UNITED STATES PATENT AND TRADEMARK OFFICE

APPLICATION NO.	FILING DATE	FIRST NAMED INVENTOR	ATTORNEY DOCKET NO.	CONFIRMATION NO.
10/538,008	06/03/2005	Tomoyoshi Yamashita	047991-5019	6861

Office Action Summary	Application No. 10/538,008	Applicant(s) YAMASHITA ET AL.	
	Examiner ROBERT MAY	Art Unit 2885

DETAILED ACTION

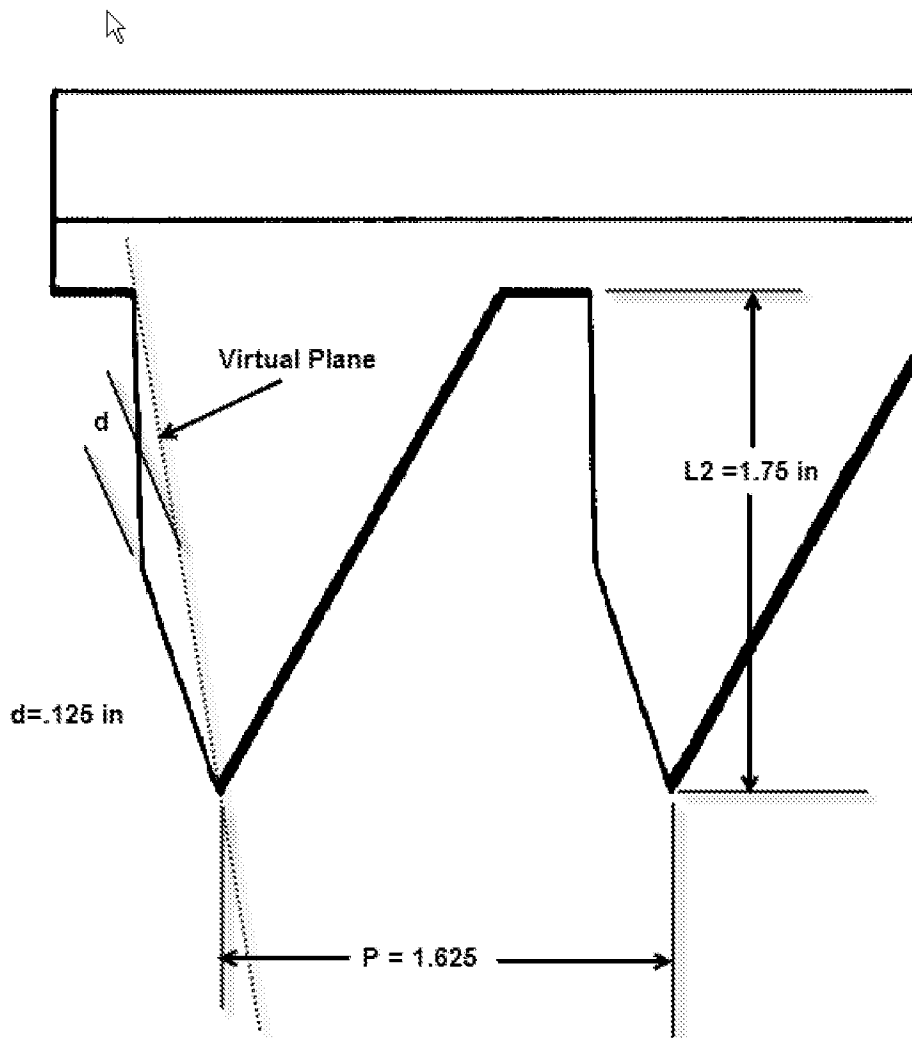
Regarding Claim 12, Miyashita fails to disclose the light deflector as claimed in claim 1, wherein a ratio (d/P) of a maximum distance (d) from the non-single planar surface to a virtual plane connecting a vertex and a bottom of each of the elongated prisms to each other relative to a pitch (P) of the elongated prisms is 0.4 to 5% (instead discloses the $d/P=7.6\%$ see the annotated Figure 16 below)

It would have been obvious to one of ordinary skill in the art at the time the invention was made to adjust the distance d in relation to the pitch P so that d/P lies within the range 0.4-5% as claimed to adjust the directionality of the light to meet the particular directional requirements of the apparatus, since it has been held by the courts that, where the only difference between the prior art and the claims was a recitation of

Regarding Claim 19, Miyashita discloses in Figure 16, the light deflector as claimed in claim I, wherein a pitch P of the elongated prisms and a length L2 of a virtual straight line connecting a vertex and a trough section of each of the elongated prisms to

each other in a cross section thereof as to one of the prism faces of the vertex split angle of each of the elongated prisms shows a relationship of $L2 / P = 1.1$ to 1.7 ($L2 = 1.75$ in and $P = 1.625$, therefore $L2/P$ is approximately equal to 1.1 , see the above annotated Figure 16).

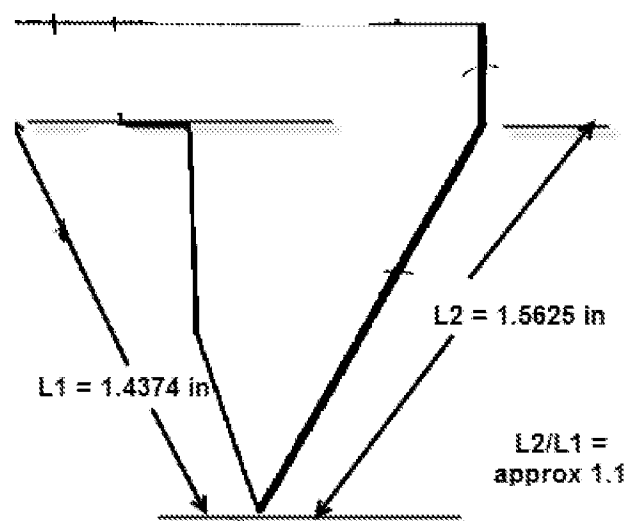
Regarding Claim 20, Miyashita discloses in Figure 15, the light deflector as claimed in claim 1, wherein a length $L1$ of a virtual straight line connecting a vertex and a trough section of each of the elongated prisms each other in a cross section thereof as to one of the prism faces of the vertex split angle of each of the elongated prisms and a length $L2$ of a virtual straight line connecting a vertex and a trough section of each of the elongated prisms to each other in a cross section thereof as to the other of the prism faces of the vertex split angle of each of the elongated prisms shows a relationship of $L2 / L1 = 1.1$ to 1.3 (see annotated Figure 15 below).
